SUBJECT: BAGGAGE DOOR, INSIDE LATCH MODIFICATION

MODEL/S/N  
EFFECTIVITY M20J: 24-0084, 24-0378 THRU 24-1650  
24-3000 THRU 24-3059  
M20K: 25-0001 THRU 25-1165  
M20L: 26-0001 THRU 26-0019

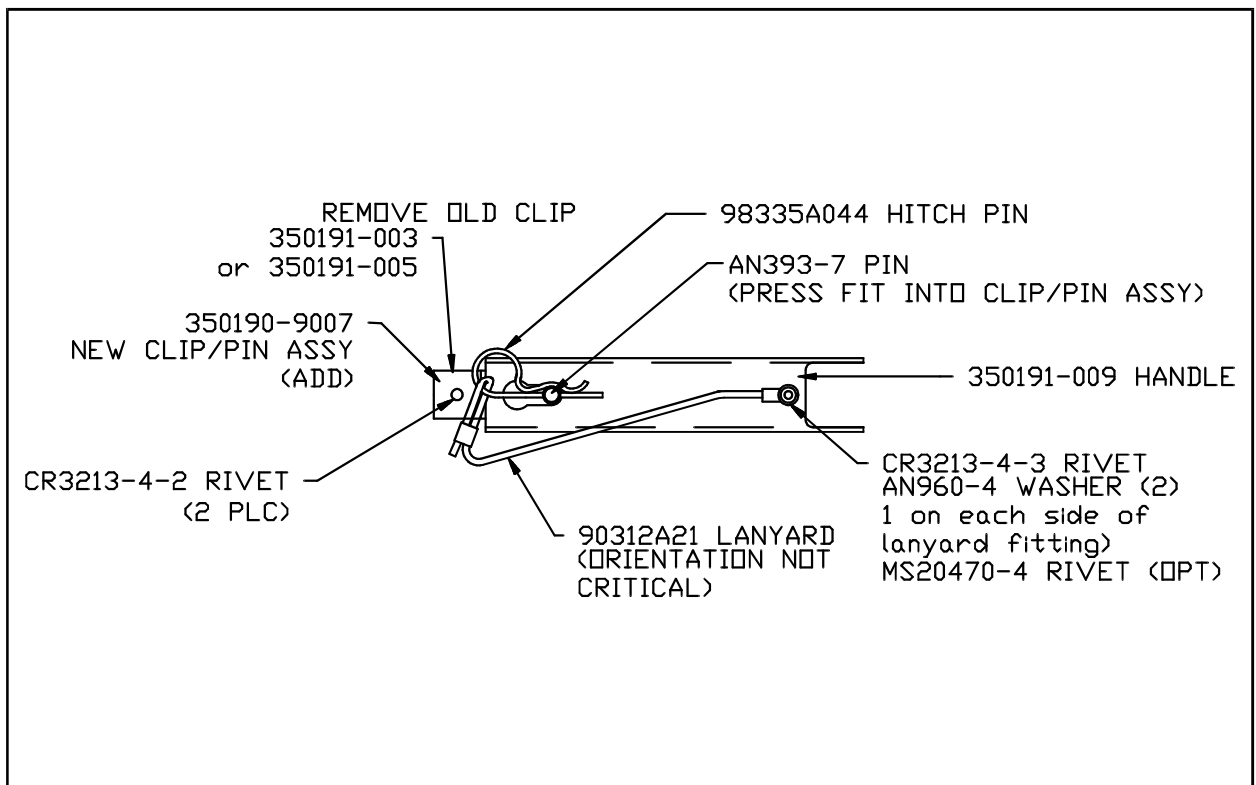
6. Remove Red Handle; remove White Knob assembly from hole in Red handle.
7. Modify large hole in Red handle to a slotted hole per Figure M20-82-1 below.

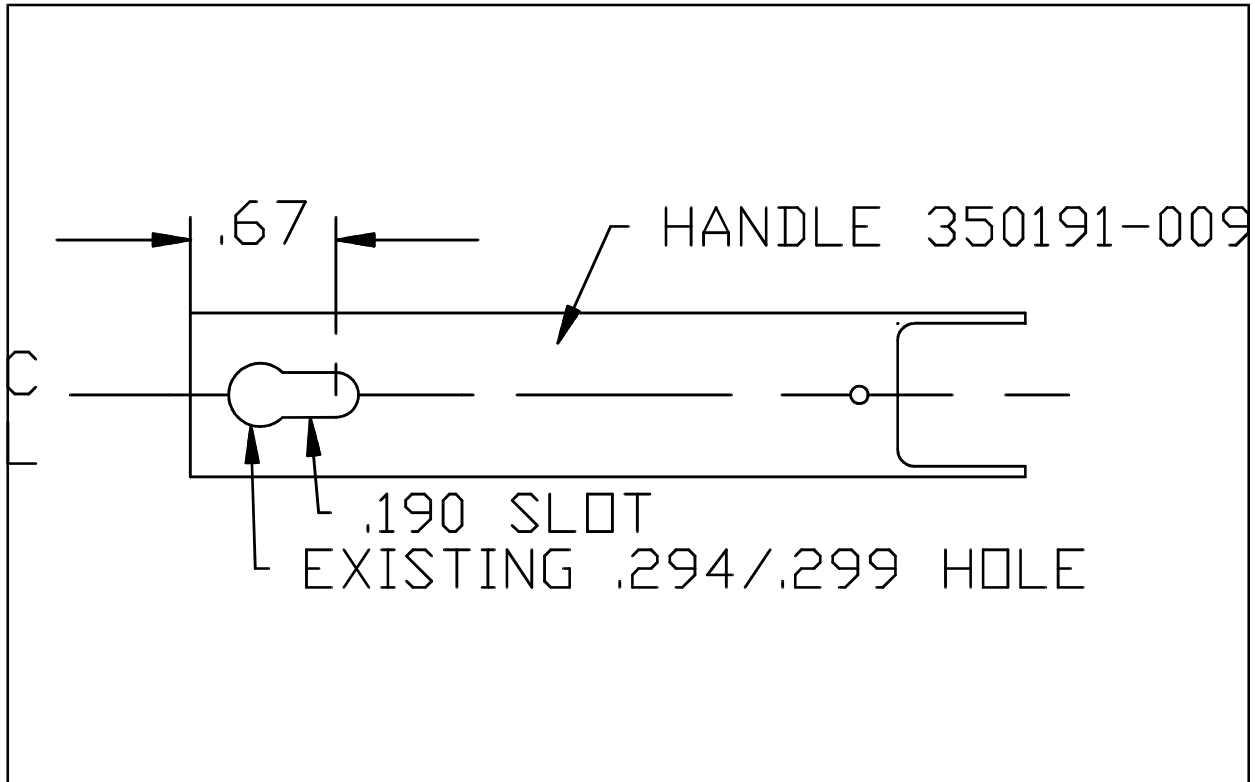
8. Remove existing clip, P/N 350191-003 or -005, from door frame by drilling out two (2) rivets (SEE FIG M20-82-2).
9. Install 350191-9007 clip/pin assembly, locating pin relative to slot in handle as illustrated in figure M20-82-2. Drill two (# 30 drill) holes into baggage door using pilot holes in clip/pin assy. as a guide. Install with two CR3213-4-2 rivets.

10. Install lanyard, P/N 90312A21, on RED handle per Figure M20-82-2. Use CR3213-4-3 rivet and two AN960-4 washers (one on each side of lanyard fitting).
